# Public Service Commission

September 15, 2009

The Reclamation Division has completed a review of Dakota Westmoreland's August 17, 2009 response to our July 10, 2009 technical deficiency letter on Revision 22 to Permit KRSB-8603. The following items must be satisfactorily addressed before we will recommend Commission approval of this revision.

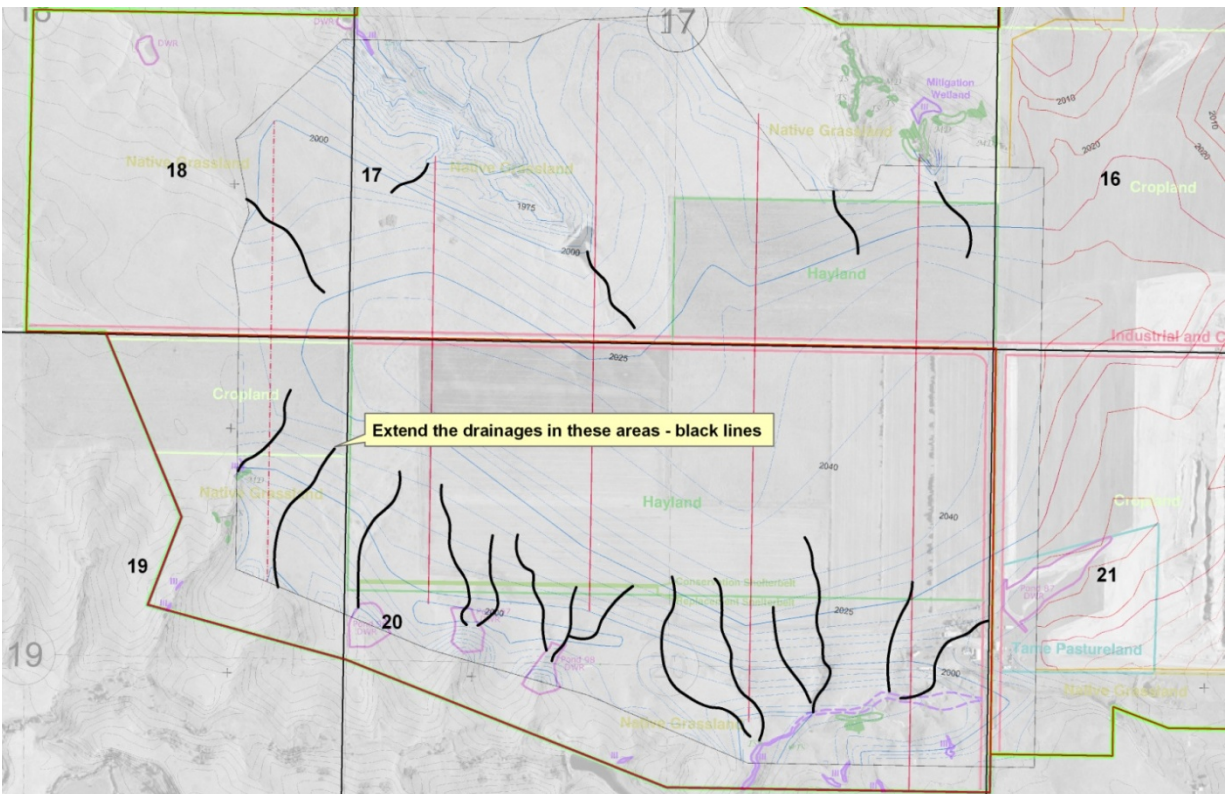
13. Please correct the error on the bottom of page 3.5.16 that states that Pond 86 is a permanent pond at the request of the landowner, when it is actually a temporary pond. (WTG)
14. Follow-up to July 10, 2009 deficiency No. 24. Please revise the Post-Mining Topography Map, Exhibit 3.5.3, to show extended reaches of secondary drainages where natural drainages meet the mining disturbance boundary. The black lines in the image below show where the Reclamation Division believes that secondary drainages should be

extended in the post-mine topography so that the drainage complements the surrounding terrain as required by NDCC 38-14.1-24(3). (GAW)
